Weston & Sampson

August 30, 2018

Re: Review of Remediation Activities at 17 Lawrence Street, Norfolk, MA (RTN 2-3000173)

FIGURE 4

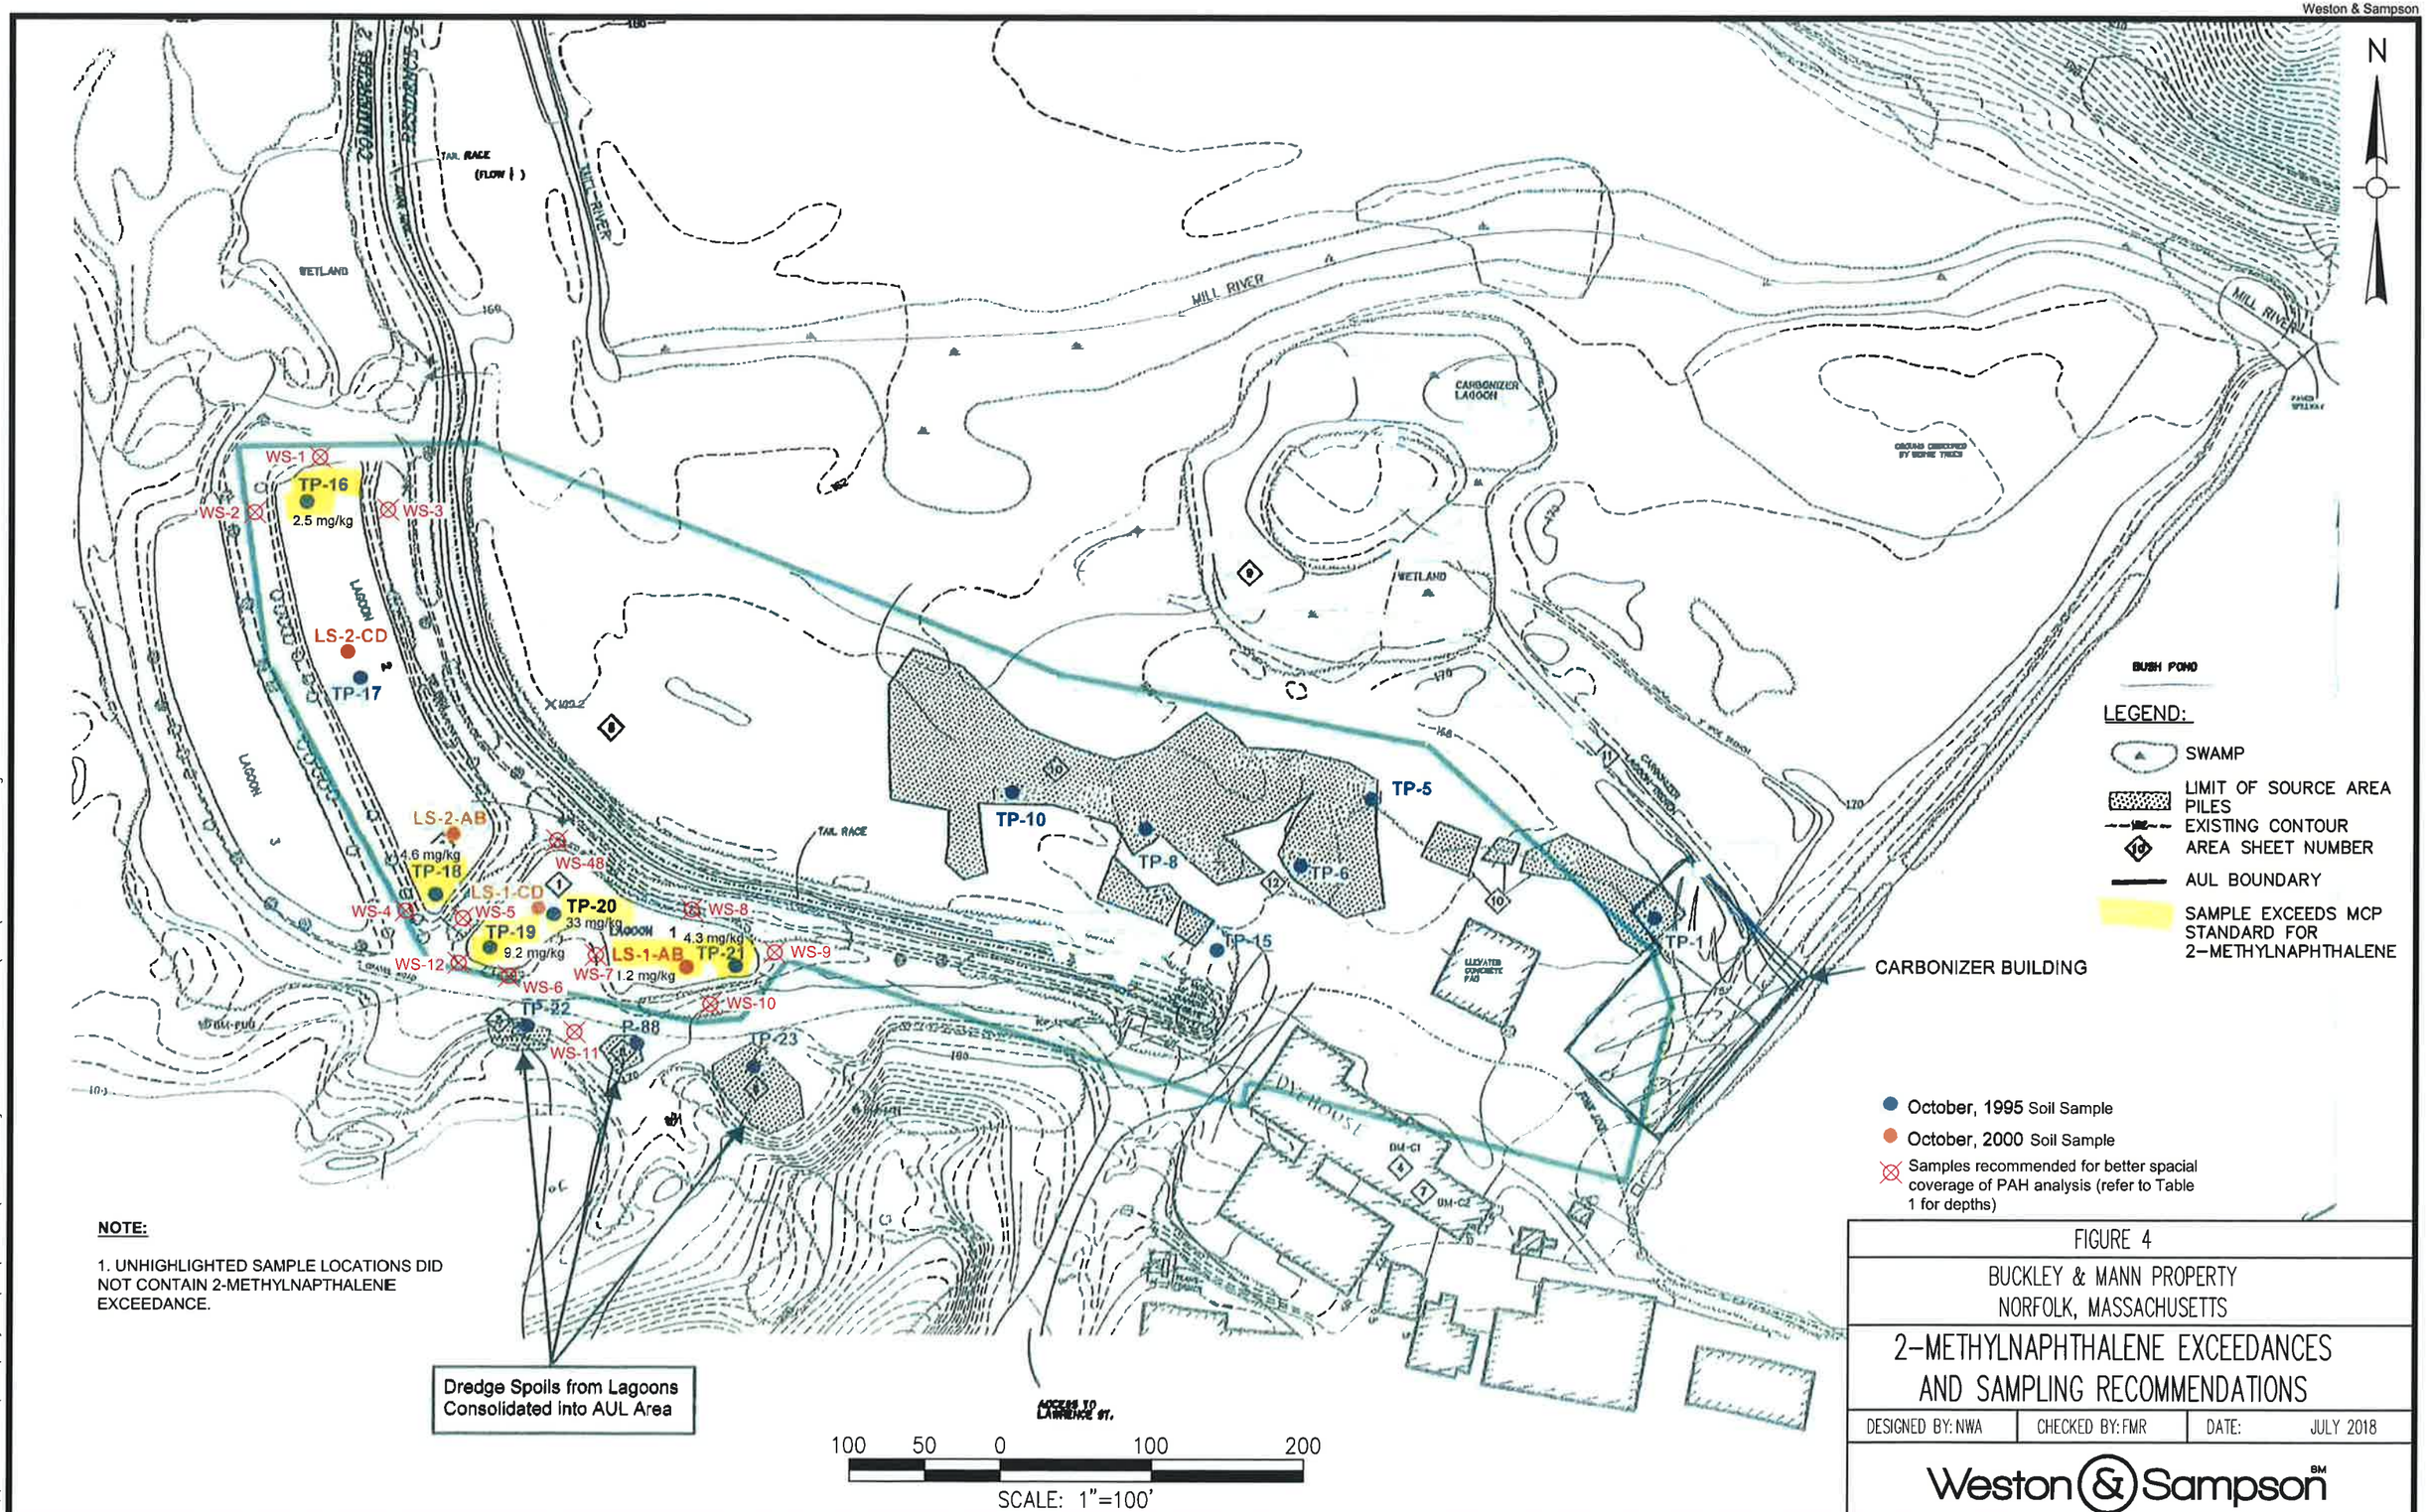
Two samples from the portion of the Carbonizer Trench closest to the lagoon, concentrations of lead and 2-methylnaphthalene exceeded Method 1 S-1 Cleanup Standards. The two samples in the upstream portion of the trench reportedly did not exceed Method 1 Cleanup Standards.

2. Additional Sampling in the Carbonizer Trench

Similar to the Carbonizer Lagoon, additional sampling of, at a minimum, the downstream portion of the Carbonizer Trench for metals should be conducted to define both the horizontal and vertical extent of contamination in this area. In addition, samples should be collected for additional parameters to evaluate ecological risk including samples of surface water and sediment (If present).

FIGURE 5

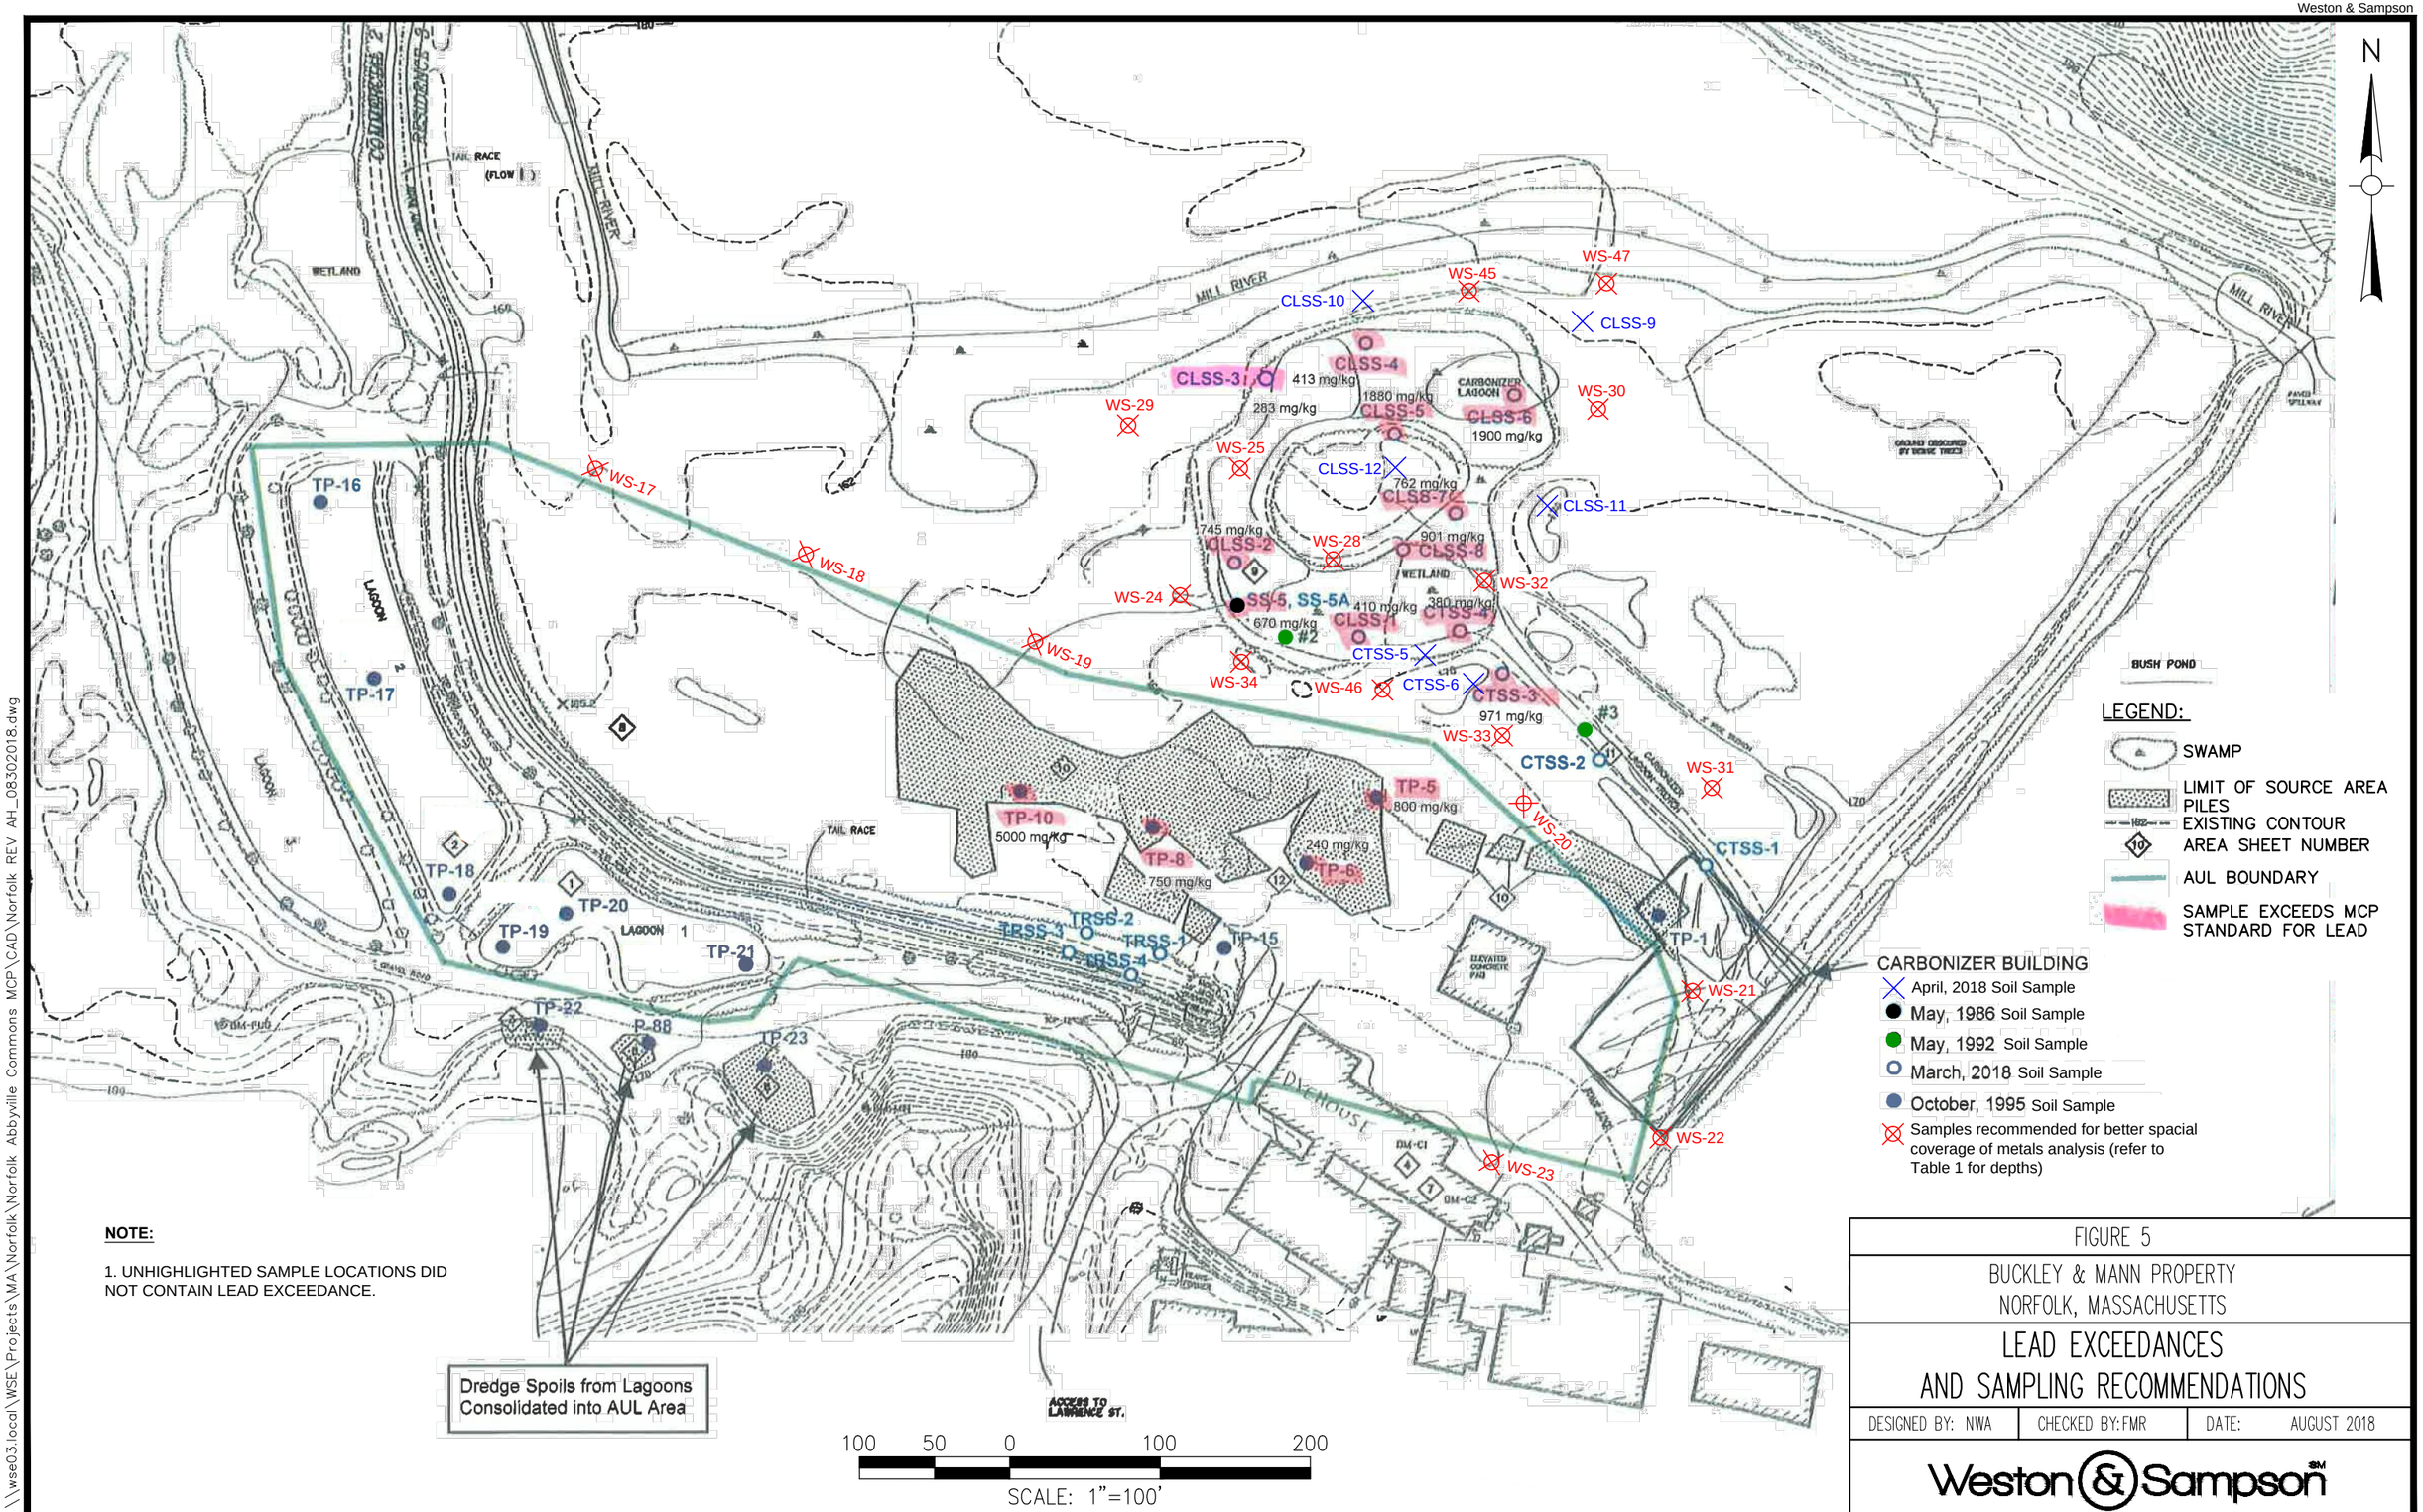
Within the Carbonizer Lagoon area, each of the collected soil samples contained lead above Method 1 S-1 Cleanup Standards, while two samples contained various additional metals above relevant Method 1 Cleanup Standards, including antimony, cadmium, trivalent chromium, and zinc.

1. Additional sampling in the Carbonizer Lagoon

The Carbonizer Lagoon area has historically shown concentrations of lead in excess of Method 1 Criteria throughout samples collected from this area. Additional metals have also been detected in surficial soils from this location above Method 1 Standards, including chromium and zinc. Supplemental sampling to determine the horizontal extent of this contamination is recommended, as a clear horizontal boundary has not yet been established. Furthermore, numerous surficial samples of the top 0 – 1 feet have been collected, but from our review of the available Mabbett and CDM documents, deeper samples have not been collected. Additional soil samples should be collected for, at a minimum, metals analysis at depth. In addition, samples should be collected for additional parameters to evaluate ecological risk including samples of surface water and sediment (If present).

FIGURE 7

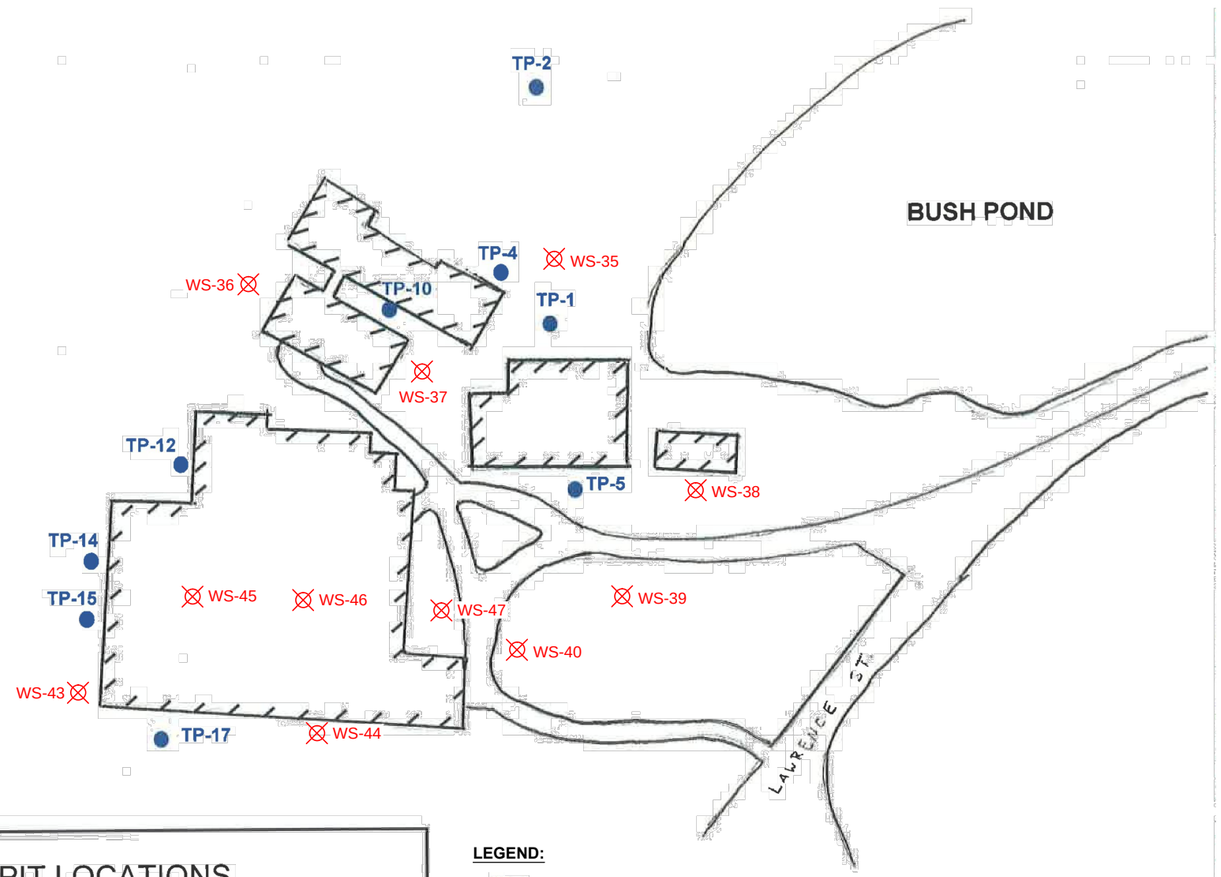
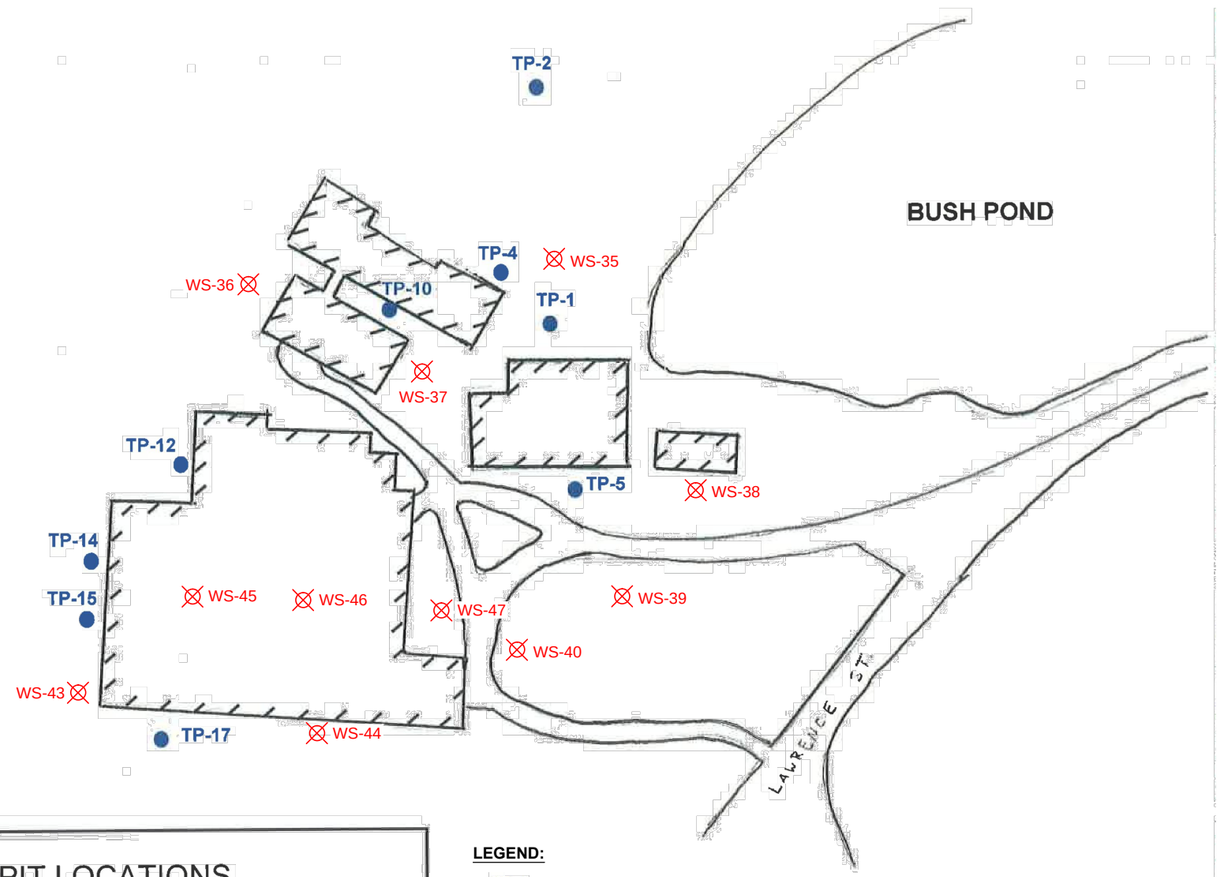
Based on these analytical results, PAH detections were likely associated with coal ash observed within this test pit location. Weston & Sampson notes that similarly to the 2013 Test Pitting investigation, a limited number of samples were submitted from a large area and number of test pits (nine samples out of twenty-three test pit locations). As such, additional assessment is recommended within these areas to improve the frequency of sampling and aerial coverage.

5. Additional sampling within the area of former on-site structures

Following building demolition, a total of sixty-one test pits were excavated within the general vicinity of, or through, the former building slabs. A limited number of analytical samples were collected from these test pits, which represent a large spatial area and may be associated with former process areas. Further assessment of these areas may be warranted, including additional laboratory sampling in the vicinity of P3 TP1, which showed evidence of lead above relevant Method 1 Standards. Additional assessment of previously untested portions of the Site should be considered on a holistic basis to obtain better site coverage following generation of a site-wide figure and assessment of data gaps.
